File Number: 9-F-25-IH

Meeting: 10/14/2025
Applicant: Logan Higgins Heyoh Architecture
Owner: Logan Higgins Arlington Downs Partnership, LLC
District: Oakwood/Lincoln Park Infill Housing Overlay District

Location: 3547 Oswald St. **Parcel ID:** 69 N E 00401
Zoning: I-MU (Industrial Mixed-Use)
Description: Revisions to multi-family building (8-G-23-IH)

Overview: Revisions to 8-G-23-IH, new multi-family building that is part of a multi-phase 8-acre mixed-use development.

OVERALL
PHASE SITE
PLAN

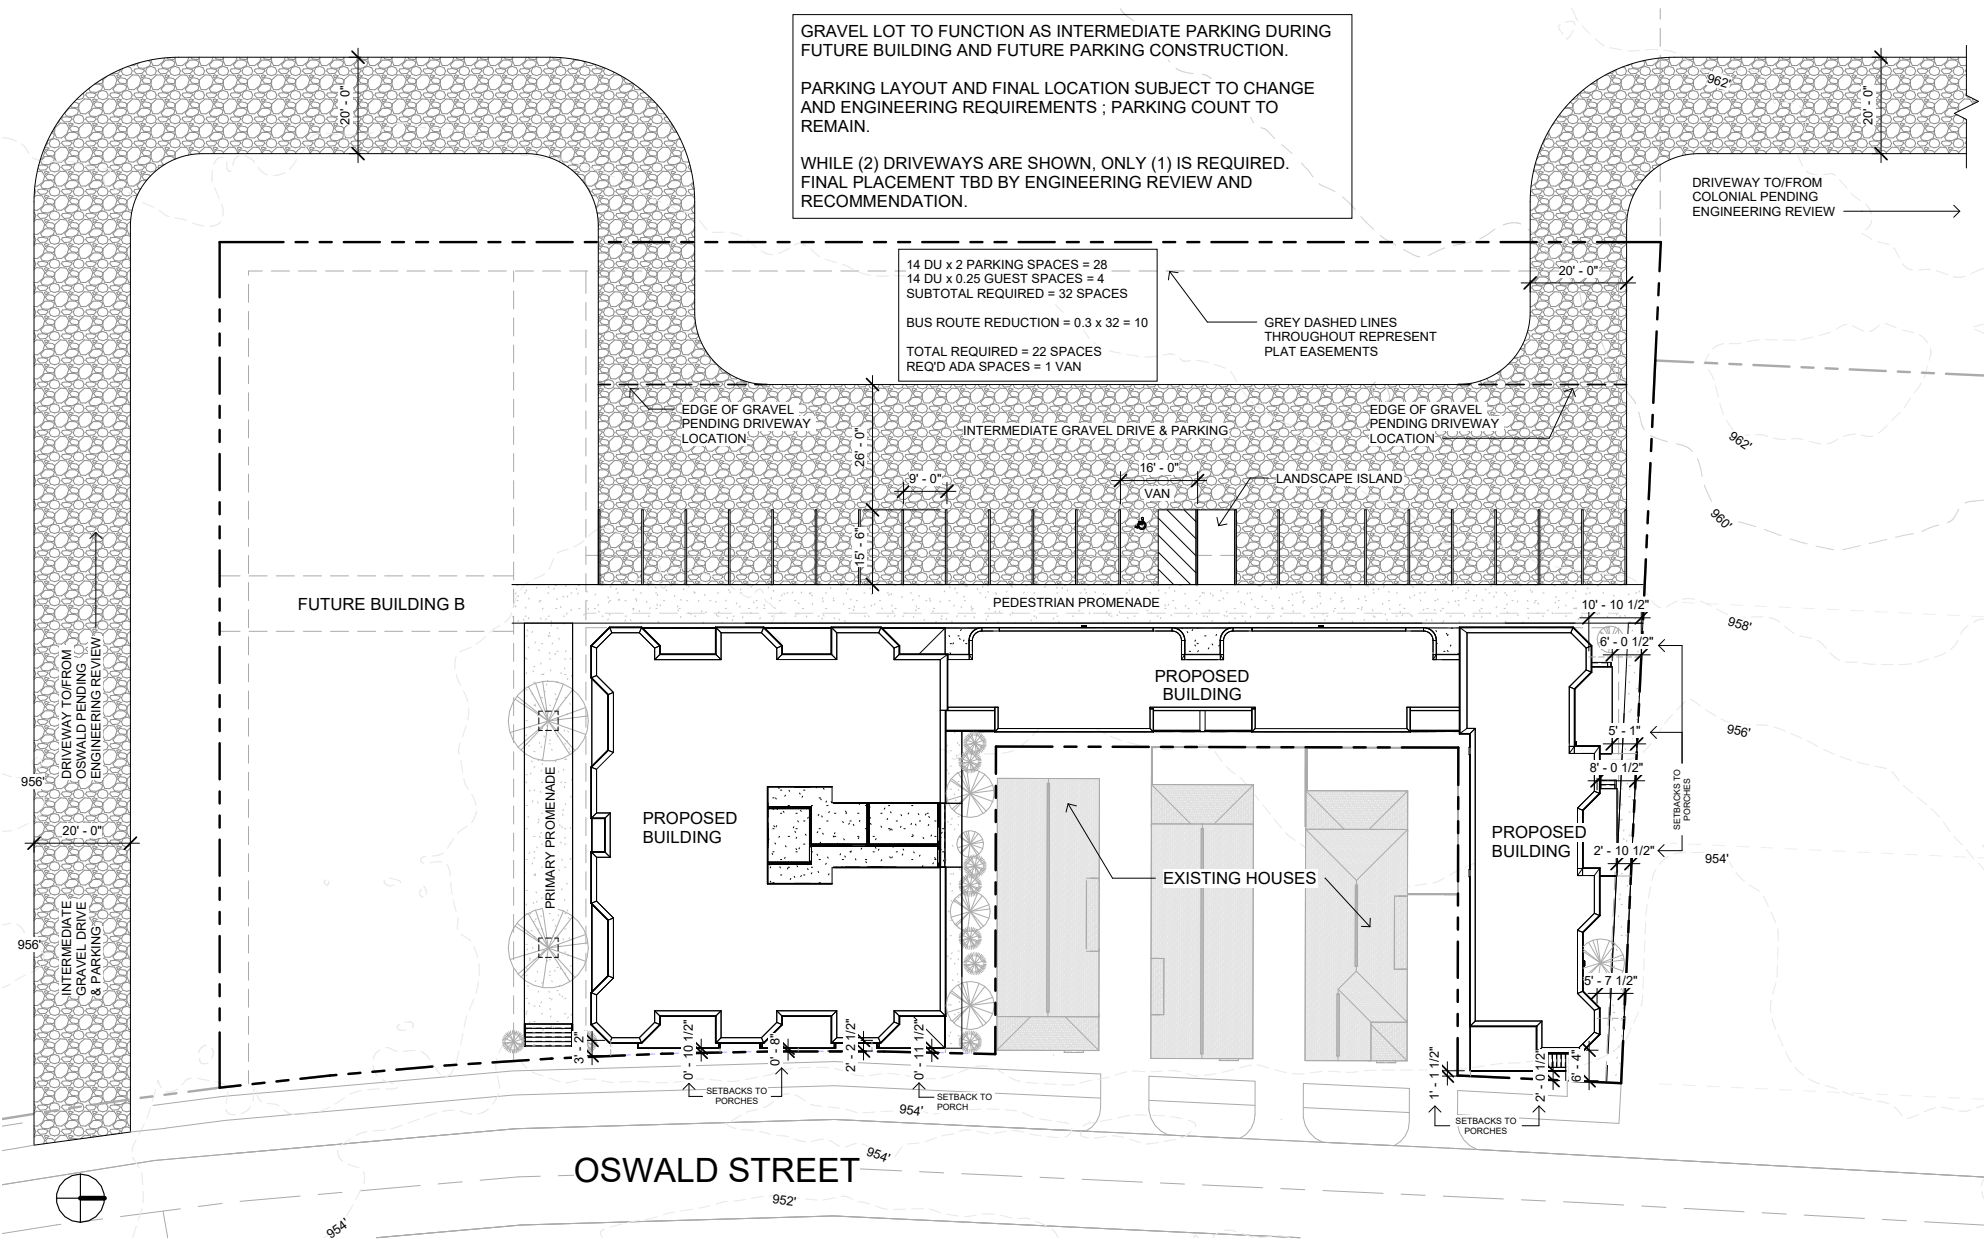
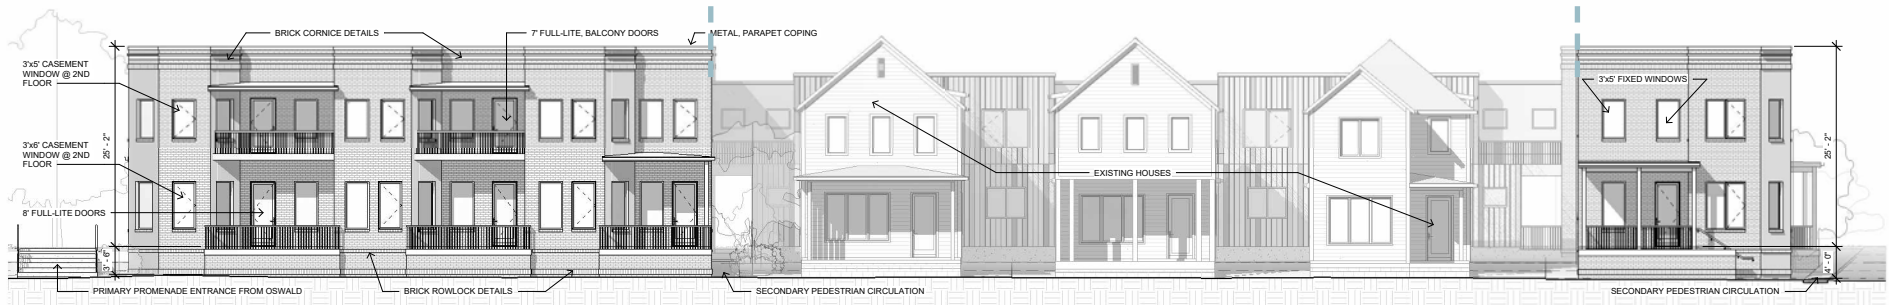
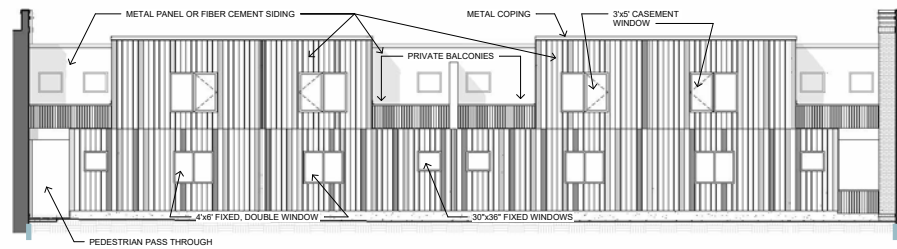
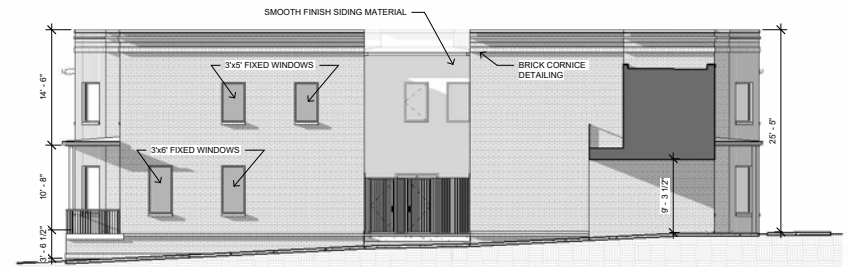
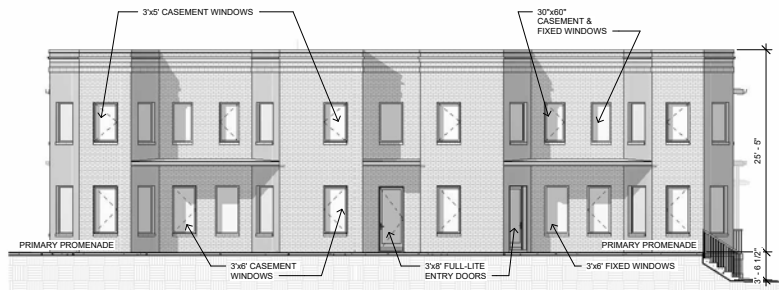
3. Parking is now provided via an "intermediate gravel drive and parking" area shown on the Phase 1.2A Plan (page 22), located to the rear (west) of the proposed buildings, with connections to both Oswald Street and Colonial Avenue. While the intent of this parking area to be temporary, it has to be considered as if it is permanent, meeting all zoning standards, since there is no guarantee if or when it will be removed. The gravel surface is an approvable driving and parking surface, pending approval by City Engineering. The parking is located behind the building, which meets design guidelines for placement, but the guidelines recommend that access be limited to one lane, as opposed to the two proposed entrances. The two entrances will allow separate access points for future residents and construction vehicles and are set far apart, so they appropriate, in the opinion of staff. With exception of the proposed access point to Oswald Street discussed below, staff is recommending that the "proposed future parking" lot shown on the Overall Phase Site Plan (page 21) be approved as part of a future application since design details are likely to change based on future submittals.

The driveway location in relation to Rider Avenue has been corrected, showing that it is offset with the intersection. Due to this, City Engineering has indicated that exiting vehicles will be restricted to right-out turns only because of conflicting turn movements at the intersection. The driveway and parking lot drive aisle width on the "proposed future parking" area have been reduced to 26' width from 30' based on the plans submitted for the September 2025 agenda. The driveway curb cut width could be further reduced to 20', but this may not be possible because of the design requirements associated with restricting turn movements. The parking lot may be required to have a 25' setback from Oswald Street since it will serve a mixed-use development and has common frontage on the same block with residentially zoned property (Article 11.3.B).

3. The parking lot setback has been reduced from 15'-4" to approximately 5', and the driveway location is now offset with the intersection of Rider Avenue. The applicant is encouraged to discuss the driveway location with City Engineering before moving forward with detailed construction plans and design development of the adjacent future building. The driveway and parking lot drive aisle scale to a width of 30', which is greater than the minimum 20' driveway and 26' drive aisle widths required. The driveway and parking lot dimensions should be reduced to the minimum necessary for adequate functionality of the average user to ensure safety for pedestrians and motorists along Oswald Street, a narrow residential road.

- a. Setback - Overlaying the two site plans, the driveway and parking has shifted about ~2.5ft closer to Oswald. If you can clarify what the 15-4 and 5' dimensions are referring to, that may help us clarify where the change is being detected.

- b. Rider alignment - Due to additional survey and plat documentation, we can more accurately place the site elements in their context. The parking lot has not moved in relation to Rider; the site plan is showing Rider in its correct position. **After discussion with engineering, we would not be able to angle parking to align with Rider. We were advised to consider a right-only exit as shown in our updated site plan.**

- c. Driveway - **After discussion with engineering, the driveway for the future parking should be the same as the drive aisle (26') minimum. However, for the intermediate, gravel parking shown in the updated site plan, we have shown a smaller driveway (20ft).**

- d. Parking Lot Dimensions - The parking lot dimensions shown on the site plan are at the minimum required. We will add dimensions on the revised set.

ELEVATIONS

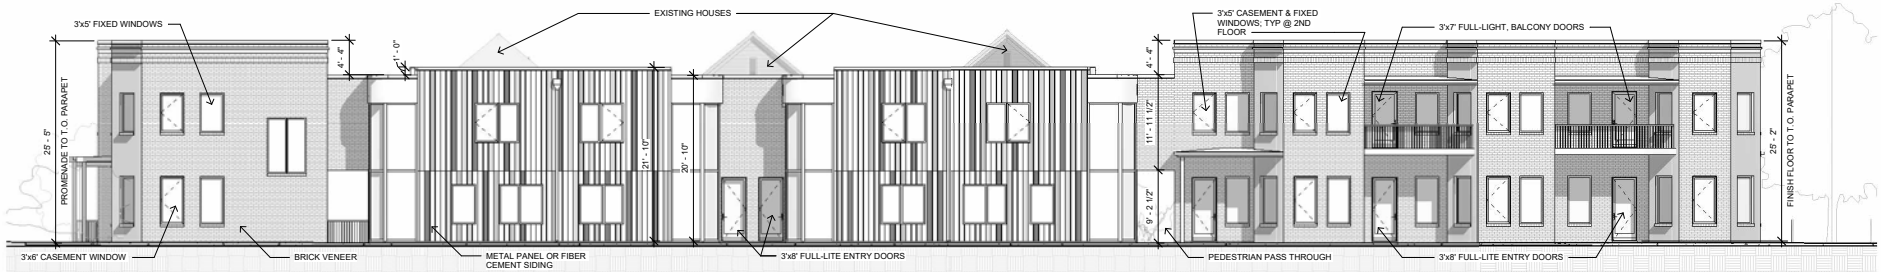
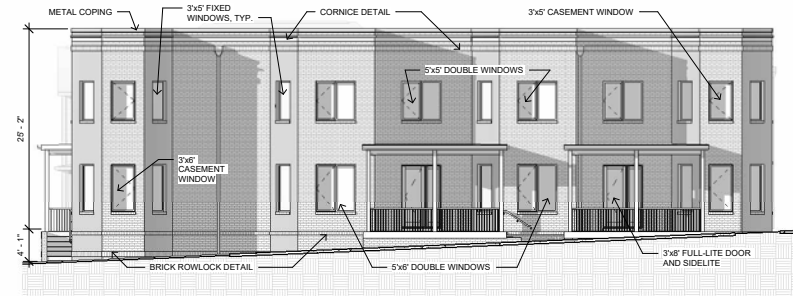
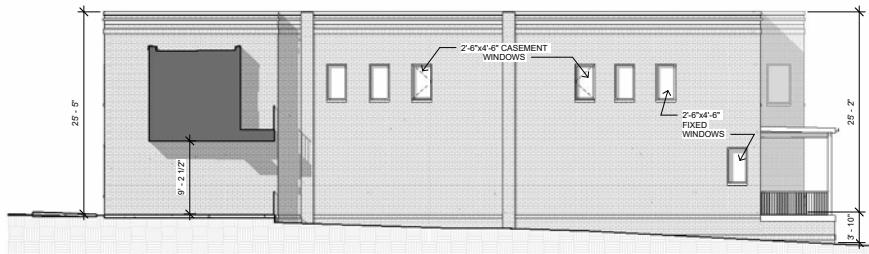
7. The conversion of all the front porches on the left (south) massing to closed patios and the removal of the associated walkways is a significant revision that does not follow the guidelines; these elements should be reintroduced. The reduction of the number and size of the pedestrian openings on the central building massing makes the pedestrian amenities less visible and accessible from Oswald Street. The revised design of the central building massing on the alley-facing west elevation provides transparency that activates the pedestrian openings and breaks the massing into smaller, varied modules, but these tactics are not employed on the street-facing east elevation.

The promenade and pedestrian openings are pedestrian entrances at the north of the overall development that provide internal public access to the proposed commercial buildings. The revisions to the east (Oswald Street) elevation obscure access to the development from the public. The Board should discuss how the revisions impact the development’s interaction with the public streetscape.

7. The conversion of all the front porches on the left (south) massing to closed patios and the removal of the associated walkways is a significant revision that does not follow the guidelines; these elements should be reintroduced. The reduction of the number and size of the pedestrian openings on the central building massing makes the pedestrian amenities less visible and accessible from Oswald Street. The revised design of the central building massing on the alley-facing west elevation provides transparency that activates the pedestrian openings and breaks the massing into smaller, varied modules, but these tactics are not employed on the street-facing east elevation.

The brick soldier coursing has been removed from all windows and doors, and the brick window sills have been removed from left building massing. The overall transparency has been reduced on secondary elevations. The previous design primarily featured single-lite casement windows on the bay window massings and fixed windows on the central building massing. The majority of the casement windows have been revised to fixed windows, which are not traditional window forms; the Design Review Board frequently requires fixed windows on single-family houses to be revised to a casement or single-hung operation. In the opinion of staff, the windows on the projecting planes of the left and right building massings on the east (Oswald Street) elevation should be revised to be operable, and the previously depicted brick windowsills should be retained on the east elevation. The Board should discuss the revisions to window placement and design.

- a. Enclosed porches - see point 2.c. for explanation on porch stair change.
- b. Pedestrian openings - The number of pedestrian entrances on the original site plan were 3 from Oswald (primary promenade, pedestrian access between the south massing and the existing house, and to the north of the northern most mass), 1 from Oswald to the parking lot, and one from the parking lot, through the future building B tunnel; the current pedestrian access points are unchanged. Please point us in the direction of a change if you have identified one.
- c. Central mass street-facing elevation - The lack of transparency on the east elevation is by design as they would be looking directly into the windows of three existing homes to their east. If the board feels like we need to include more windows, we can consider this.

- a. Brick soldier coursing - This is not intentional - we will add more brick detail to that block to match the north block.
- b. Casement vs. fixed - Previous DRB application did not show many casement windows. However, we will revise to include more operable windows per this recommendation.
